DE08-04 – Design Exception for Street Light Spacing – Spy Glass Ridge (Chapter 8.1), DE09-04 - Design Exception for Block Length – Spy Glass Ridge (Chapter 5.1.1), and DE10-04 – Design Exception for Cul-de-sac Length – Spy Glass Ridge (Chapter 5.1.3).

DESIGN EXCEPTION #DE 8-04

TEDS EXCEPTION PROJECT STAFF ANALYSIS

Subject: *Spy Glass Ridge – Request for TED's Exceptions*

Recomm
Lighting
Locations
Spy Glass Ridge

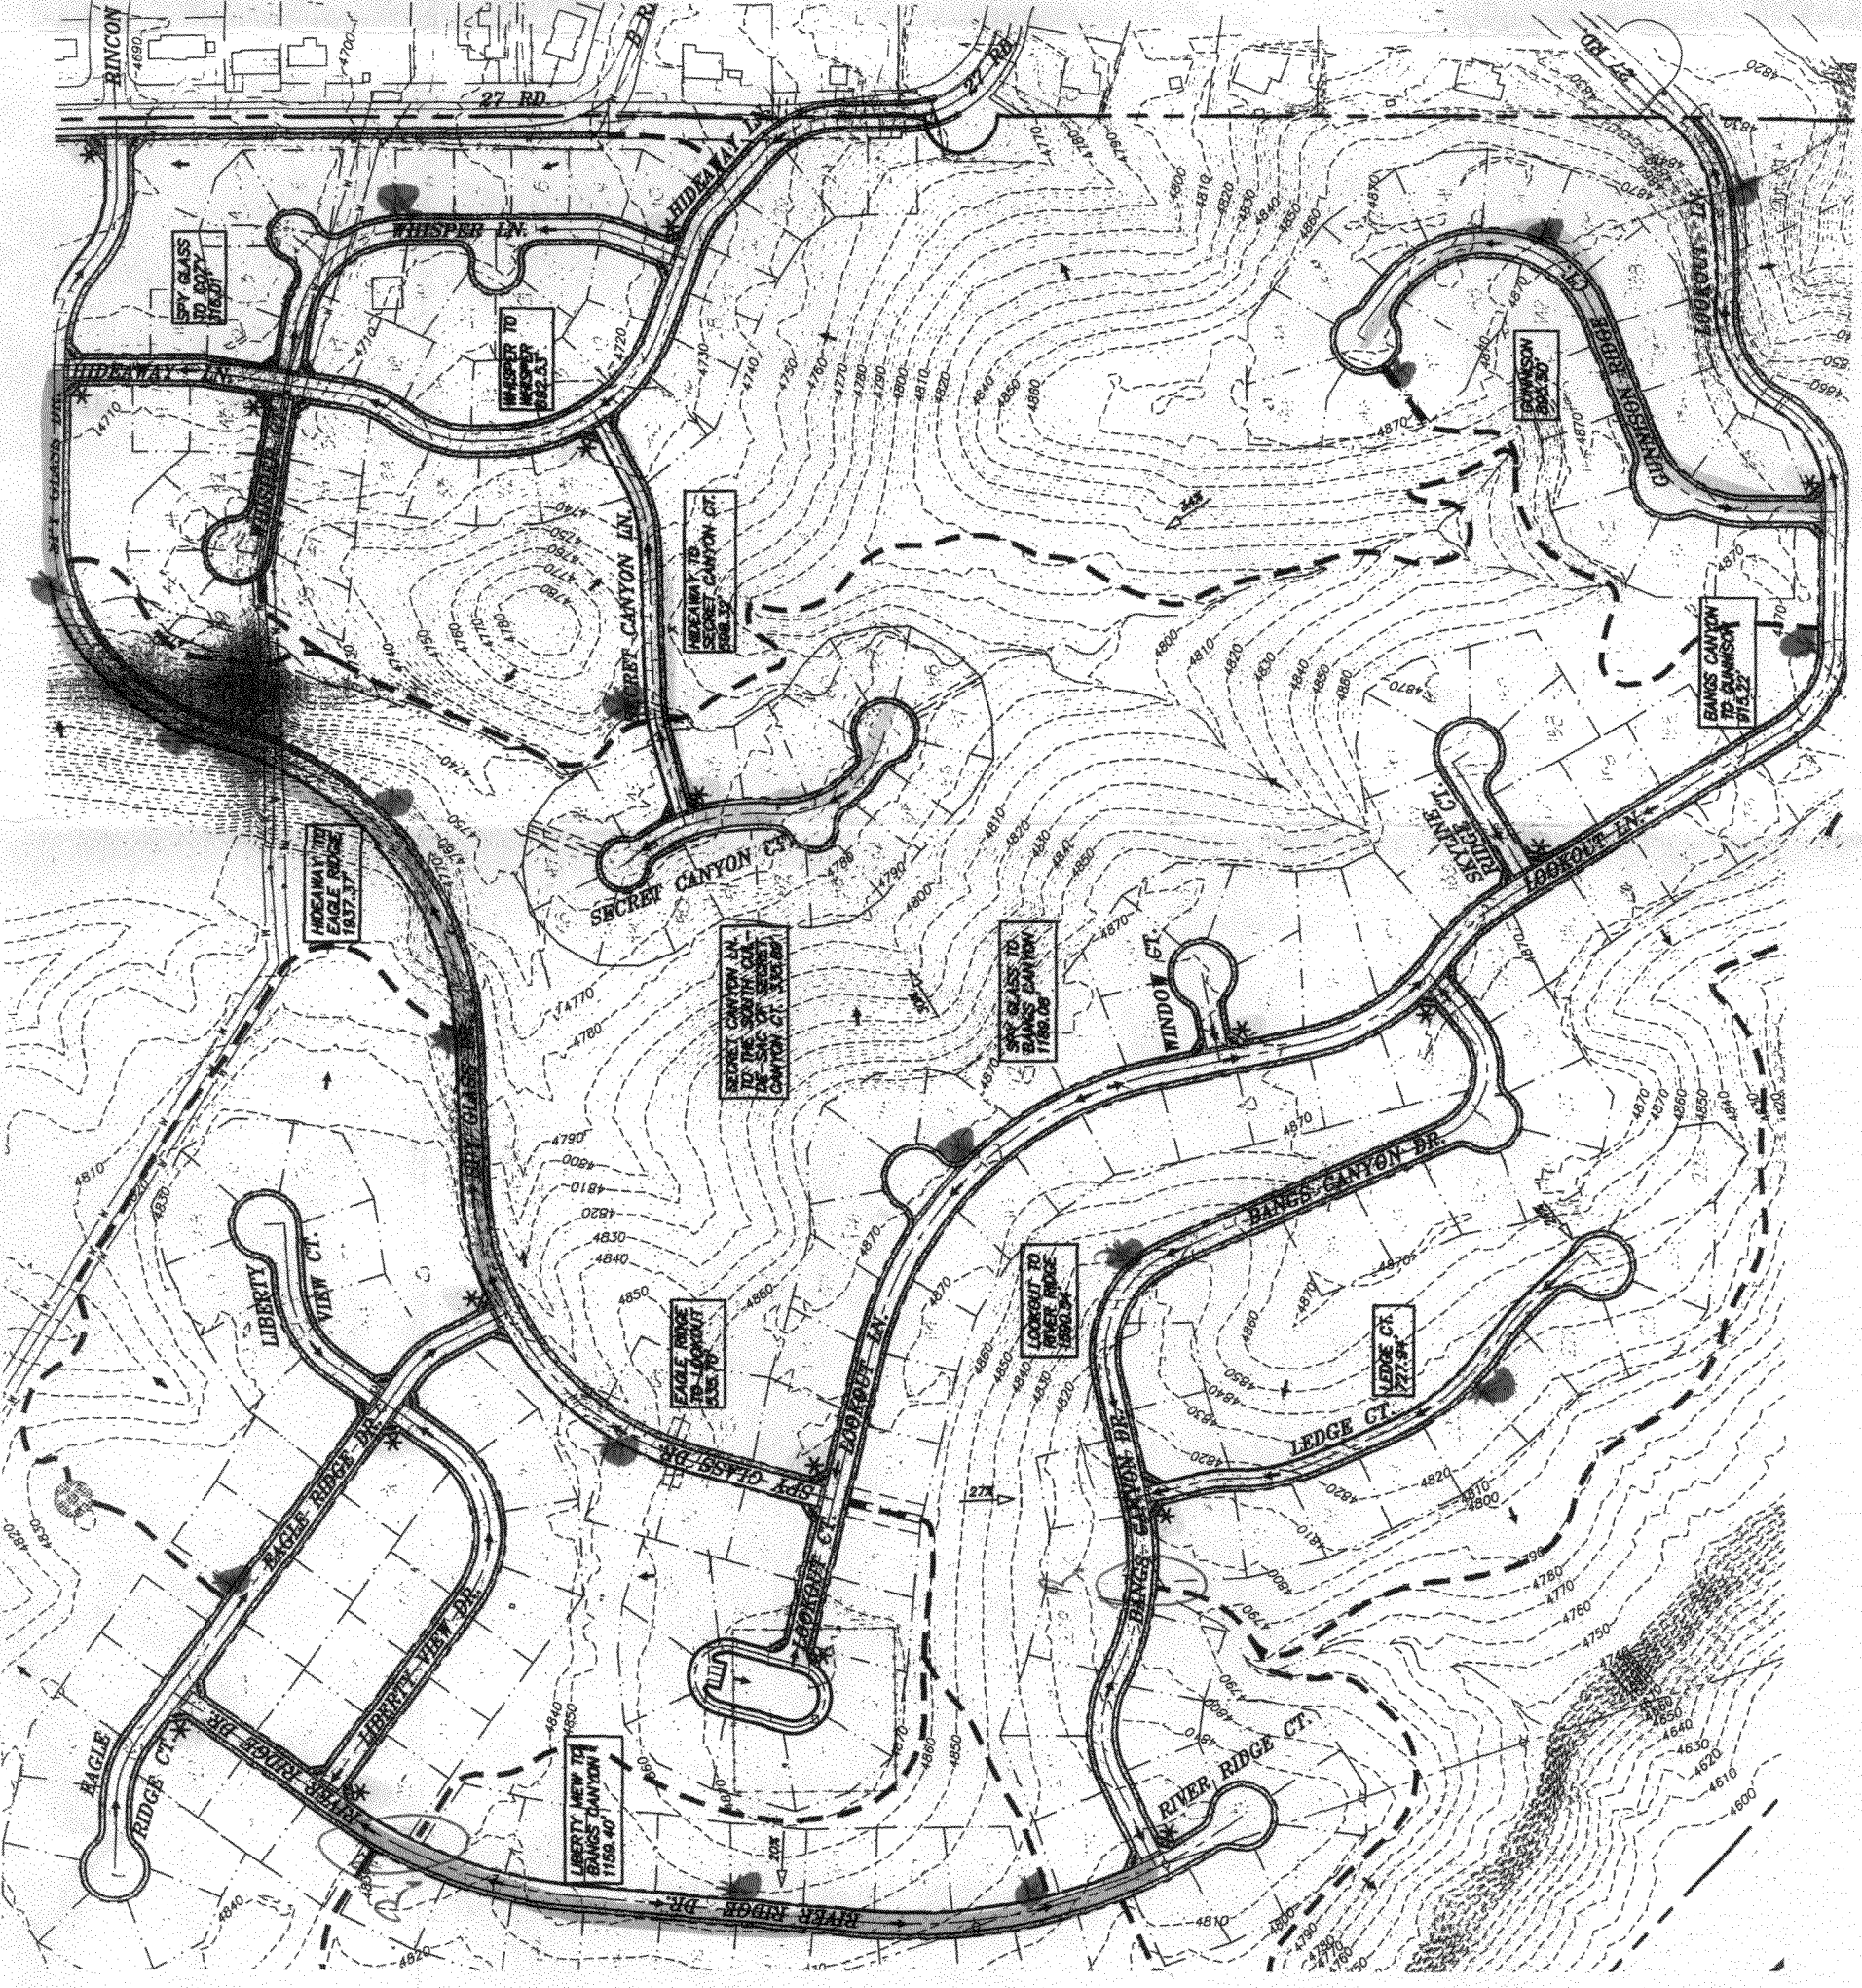
The proposed 18 lighting locations represent close to a 2/3 decrease in the number of fixtures required by our standard. Staff also feels that lights must be located at the 17 critical locations, as marked on the attached sheet.

- Potential costs to City for installation of street lighting after project acceptance
- Roadway lighting at areas of more extreme roadway geometry
- Roadway lighting near pedestrian path connections.

Staff does **not** recommend approval of this exception as currently proposed.

Staff understands the applicants desire to limit the impacts of street lights in this area, but has concerns related to the safety of the resulting roadway and pedestrian system. Staff is recommending a compromised plan that would include the placement of lights at the connections to pedestrian paths. Additionally, if the final roadway design includes areas of extreme geometry or grades that creates a concern for safety, additional lights may be required to mitigate those concerns.
